Thank you for providing the Ontario Ministry of Natural Resources (MNR) the opportunity to review and comment on the draft Environmental Report (ER), dated August 2012, for the proposed Wabageshik Rapids Generating Station.

XENECA'S RESPONSE TO MNR COMMENTS ON WABAGESHIK DRAFT ER

Xeneca Power Development Inc.
Vermillion River: Wabageshik Rapids – Proposed Operating Flows and Level Charts

Figure 4

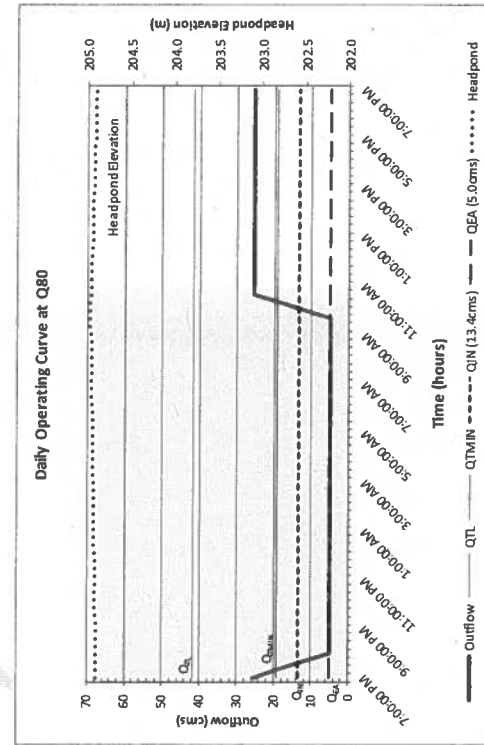
1563	RS	On Figure 4 it is not clear on why the LTAF NOL would be at the upper limit or extent of the 100 year flood elevation?	Annex 1	22	0	0
1564	RS	Figure 5 - there is a comment made with respect to the modeling artefacts and results in the post-project LTAF being above the pre-project LTAF. More details and additional explanation are needed on this modelling artefacts dealing with what caused why it cannot be removed from the model and what is the impact on this artefact on other runs of the model. Note that this is not in accordance with Figures 4 6 and 8 which show all show an increase in headpond level from pre to post development.	Annex 1	23	0	0
1558	RS	There needs to be comments and justification on why there was only a desktop study undertaken for potential erosion. There should be comments on why there was no need to go to the site and inspect/investigate to ground truth assumptions. A site visit should have been undertaken to confirm assumptions. Specifically there is a concern with respect to the scour potential of the downstream cobble bed.	ER	0	0	0

- *The report states that "upstream storage will be very limited" and does not clearly discuss the distinction between the headpond and the hydraulic link with Wabagishik Lake. The headpond will include Wabagishik Lake and the report should clearly state this. What is the effect of this hydraulic connectivity to Wabagishik Lake levels? Figure 4. does not reflect this. [Rich Pyrcce (MNR NESI), March 19th, 2013]*

1563	RS	On Figure 4 it is not clear on why the LTAF NOL would be at the upper limit or extent of the 100 year flood elevation?	Annex 1	22	0	0	The hydraulic modeling work made certain assumptions on lake levels. It became clear after we saw the model results that the lake level would have to be lower than 205.0 mMSL at LTAF flow to "follow natural lake levels" as is committed to by Xeneca. Xeneca will ensure that the version of the operating plan that is release to the public will contain the appropriate value that is consistent with Xeneca's commitment to follow natural lake level.	
1564	RS	Figure 5 - there is a comment made with respect to the modeling artefacts and results in the post-project LTAF being above the pre-project LTAF. More details and additional explanation are needed on this modelling artefacts dealing with what caused why it cannot be removed from the model and what is the impact on this artefact on other runs of the model. Note that this is not in accordance with Figures 4 6 and 8 which show all show an increase in headpond level from pre to post development.	Annex 1	23	0	0	Xeneca has made a firm commitment to "follow natural lake level". Xeneca has installed water level meters and developed a rating curve for this purpose. We will ensure that this commitment is clearly explained in the Operating Plan before it is released to the public.

Figure 5

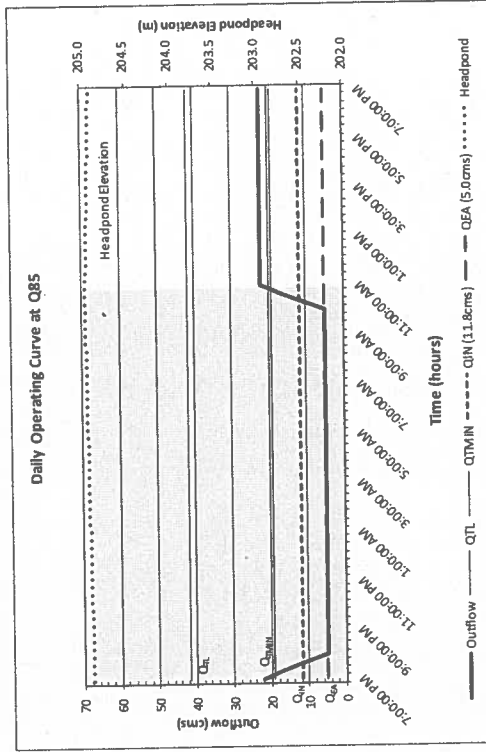
- *Figure 5. – Does this figure display actual modelled data? [Rich Pyrcz (MNR NESI), March 19th, 2013]*

- *Email states: "Figure 5 clarifies that the facility will follow natural lake level at all times using a rating curve derived from monitoring data."*
 - *Defer to regional engineer / hydrologist as to whether they have satisfied prior concern re: clarifying stated intent to follow natural lake levels [Wayne Selinger - Comments on email from Uwe Roeper March 14, 2013]*

Figure 7

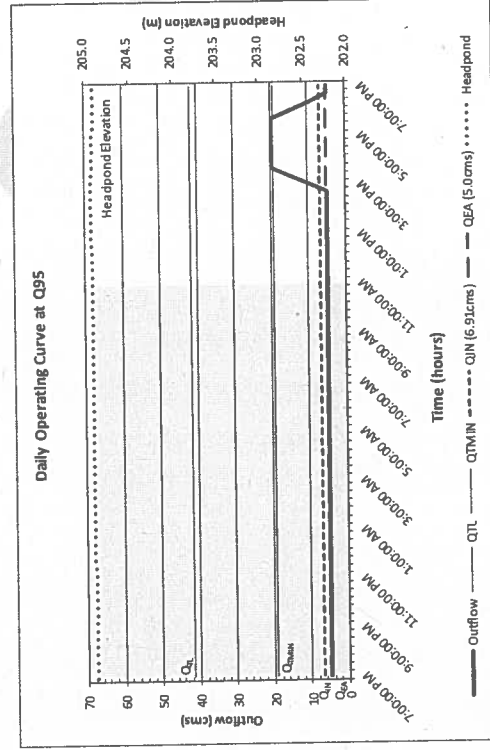
- A graph, similar to Figure 7, would be helpful in visualizing the fluctuating head pond levels throughout the year and throughout the day. [Rob Schryburt - April 9, 2013 email]*

- *Section 7.2, Downstream Operating Parameters - Figure 7 does not appear to reflect agreed upon limits to downstream operations. For example:*
 - *Minimum operating target does not reflect latest QEA values as presented in Table 5.*
